CIVA Free Known Programme 1

Power Intermediate / Yak-52, Advanced and Unlimited 2018

Guidance for competitors

Unlimited power category

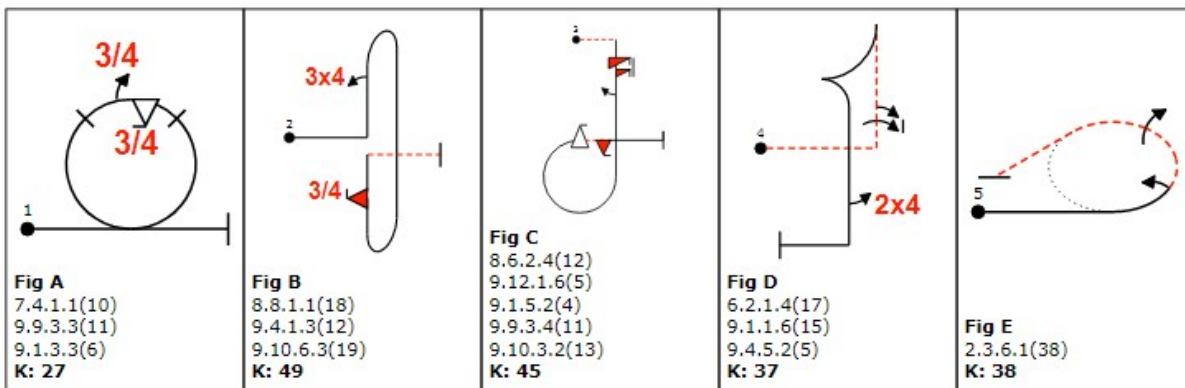
Note 1: Unlimited power Figure #3 has been revised from the original version

- The duplicated 2x4 roll (9.5.4.2) after the spin is now changed to a 1/2 roll (9.1.5.2)
- The flick-roll pair is now set to opposite directions per Aresti regulations

Note 2: With Unlimited power Figure #5 (2.3.6.1) set as a mandatory item, all unlimited Free Known sequences must include a further rolling turn to meet versatility requirements per Section 6 Part 1 para 2.2.1.8
